RESPONSE TO AN BORD PLEANÁLA OPINION

DUNDRUM CENTRAL SHD

PROPOSED STRATEGIC HOUSING DEVELOPMENT ON LANDS AT CENTRAL MENTAL HOSPITAL, DUNDRUM ROAD, DUNDRUM, DUBLIN 14

MARCH 2022

Figure 2.4: Extract from *Architectural Design Report*, prepared by Reddy A+U showing cycle and pedestrian routes and connections across the site.

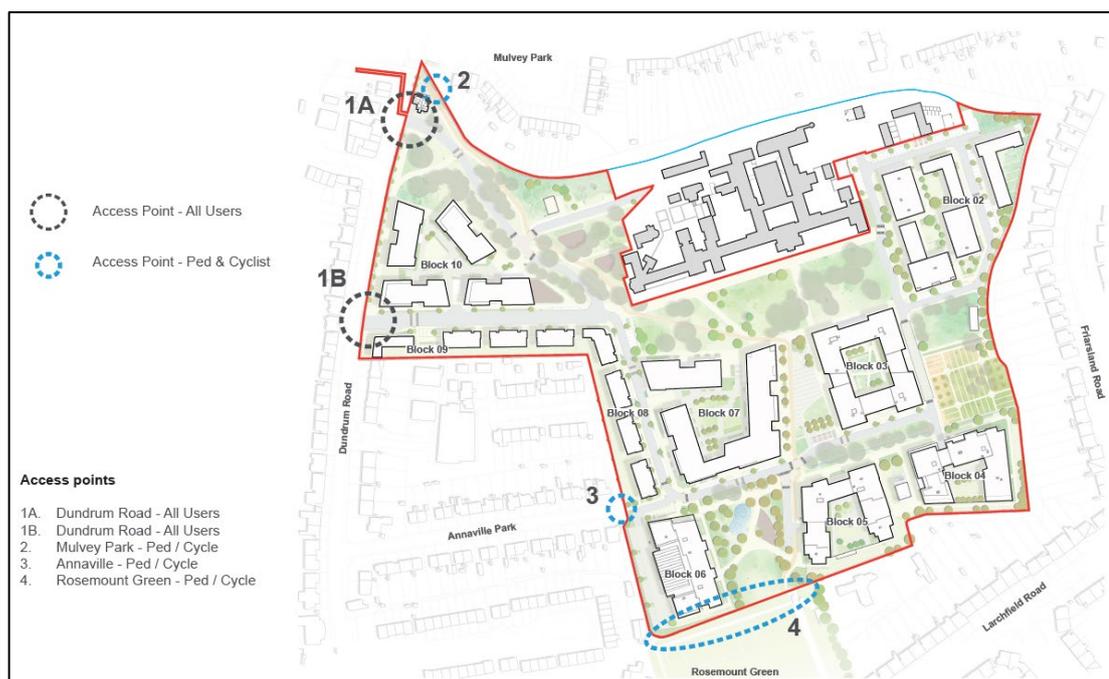
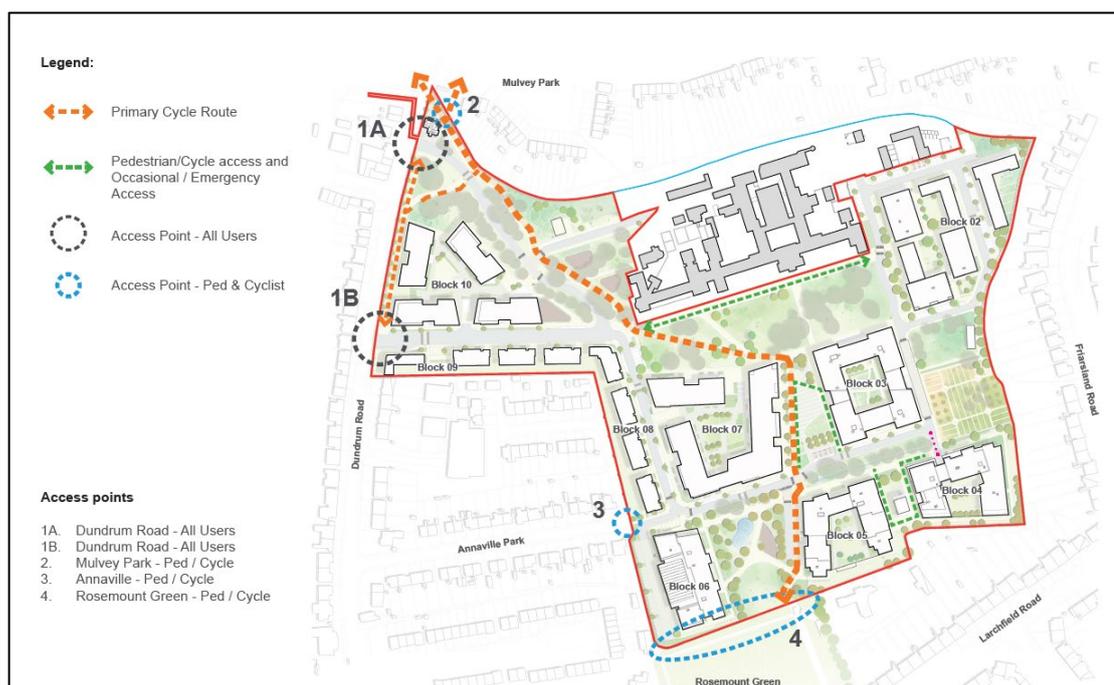
- (c) Pedestrian and cycle links to adjoining lands and connections to public transport routes and cycle/pedestrian infrastructure.*
- (d) A response to the issues raised in the Report of the Transportation Division of Dun Laoghaire Rathdown County Council, as contained in the Planning Authority's Opinion dated 23rd July 2021.*

The proposed development includes a number of new pedestrian and cycle links which provide connection between the subject lands and the surrounding area. Given the current insular nature of the lands, the proposed connectivity results in a significant enhancement to permeability in the local area. In summary, the proposal includes the following new cycle and pedestrian access points:

- Formation of a new opening in perimeter wall at Annville Grove to provide a pedestrian and cyclist access.
- Removal of sections of wall adjacent to Dundrum Road, including the provision of a new vehicular, cyclist and pedestrian access.
- Removal of section of perimeter wall adjacent to Mulvey Park to provide a pedestrian and cyclist access.
- Removal of section of perimeter wall adjacent to Rosemount Green to provide cycle and pedestrian connectivity.

Page 34 of the *Architectural Design Report* provides an illustrative site plan showing the proposed pedestrian and cycle links. An extract is provided below:
